# CITY OF ALBUQUERQUE

**RE: 6508 Jade Dr. NW**  
**Revised Grading & Drainage Plan**  
**Engineer's Stamp Date: 02/23/23**  
**Hydrology File: E10D113**

Based upon the information provided in your submittal received 02/27/2023, **the Revised Grading & Drainage Plan is not approved for Building Permit.** The following comments need to be addressed for approval of the above referenced project:

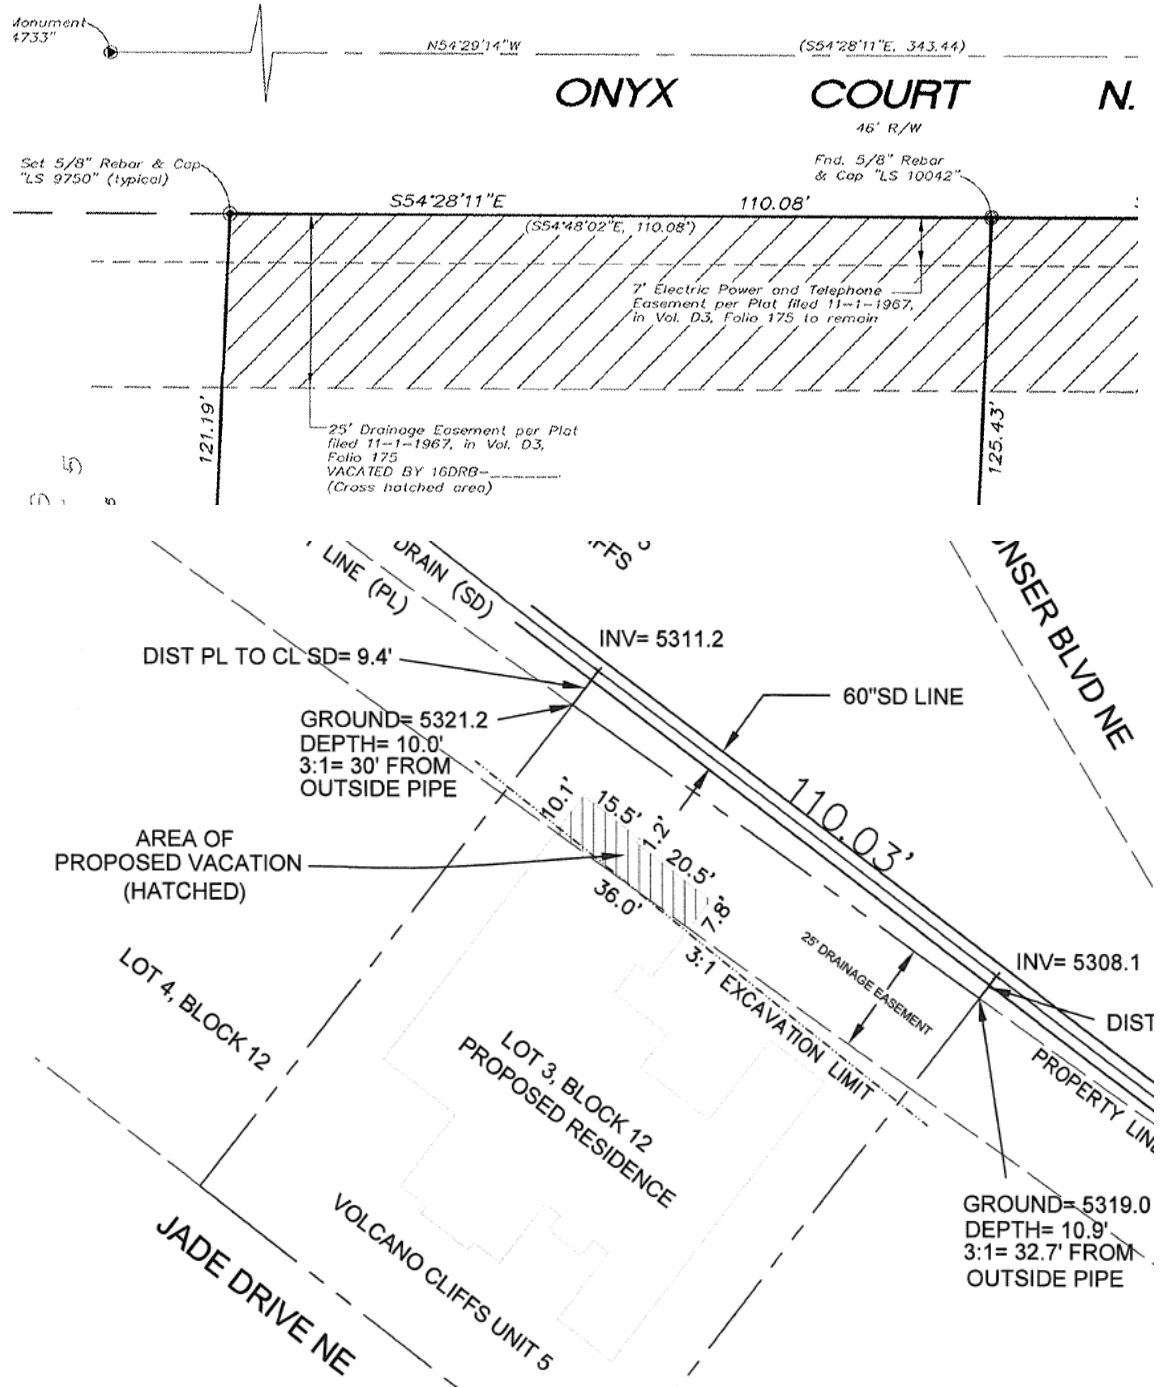
1. There is an existing 25-foot Public Drainage Easement along the rear Property line that is not shown (The Plat was filed 11-1-1967 in Vol 3, Folio 175). Both the proposed house and proposed pool is within this easement. (see below the trench prism layout that was done during the DRB application PR-2022-006614 for a vacation of this easement which was withdrawn by the applicant in June 2022. This property was previously approved with an incorrect Grading & Drainage Plan which did not show this easement on March 29, 2022. At the DRB, the applicant was informed that the house which encroaches about 10 feet into the existing 25-foot Public Drainage Easement would need to be relocated outside of the easement. **Please note that since this did not happen, Hydrology will not be able to approve the house for Permanent Certificate of Occupancy.**
